Town of Innisfil Building Dept Notes:

PROJECT NAME
ALCONA SHORES

BLOCK 141
BLOCK PLANS & ROOF PLAN

unit name		unit no.	
---		BLOCK 141	
		title	
		BLOCK ELEVATIONS	
date	scale	drawing no.	
FEBRUARY 2018	1/8" = 1'-0"	B141.3	
drawn by	checked by	file name	
--	--	13049-BLOCK

GROUND FLOOR PLAN

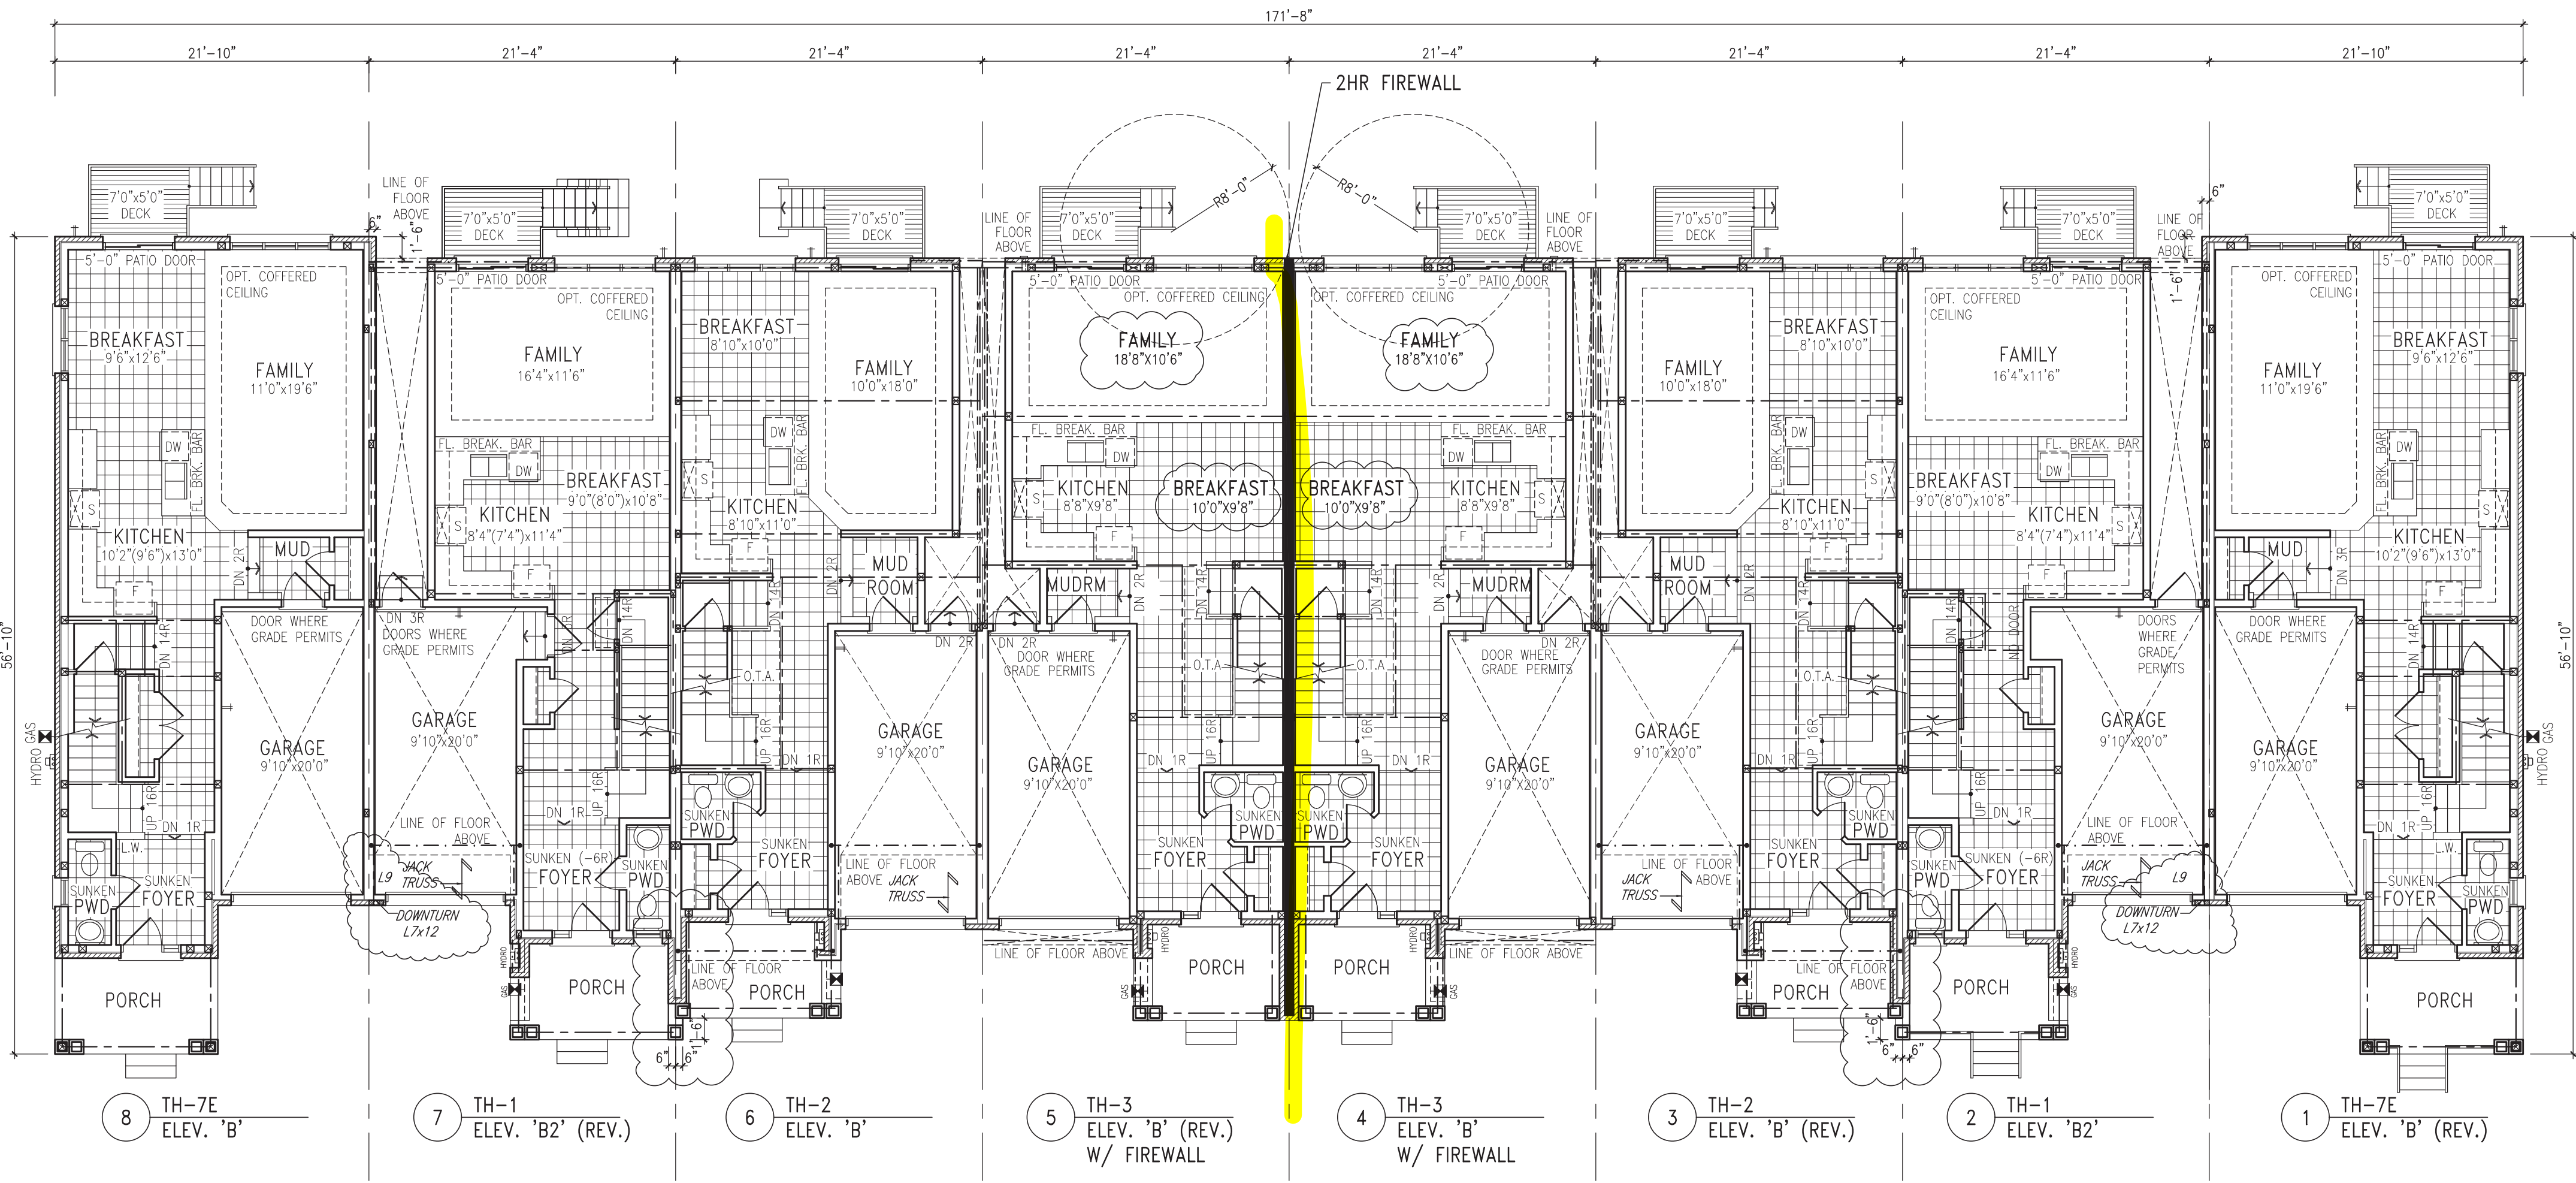
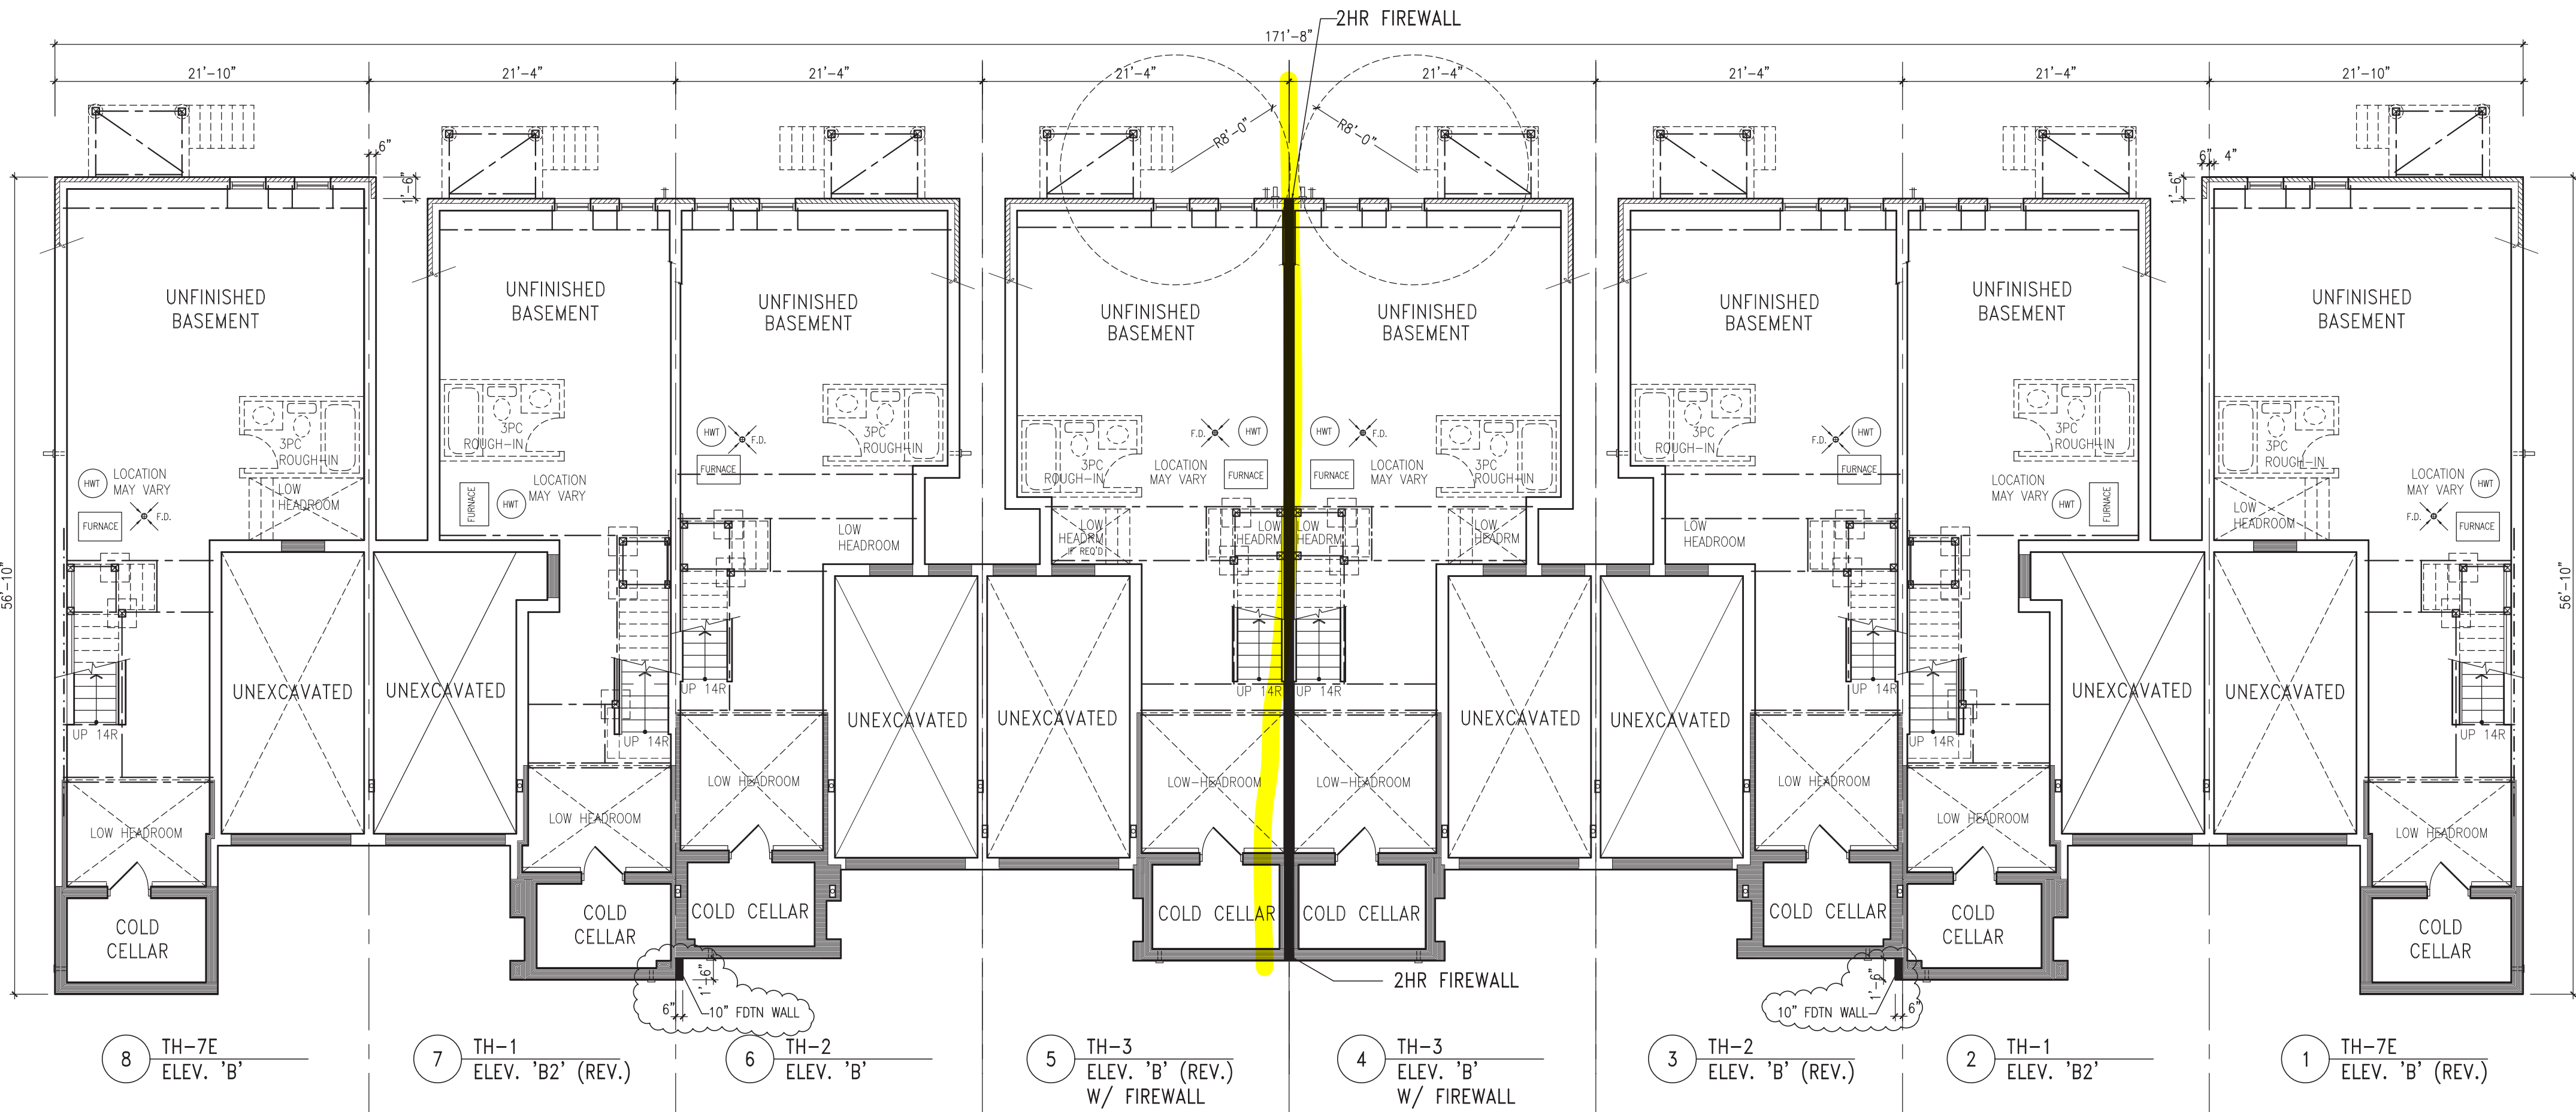
All smoke alarms and CO detectors shall
comply with O.B.C 9.10.19 and 9.33.4

Main bathroom shall be designed as per 9.5.2

All construction subject to review by Town
Building Inspectors

See comments on permit
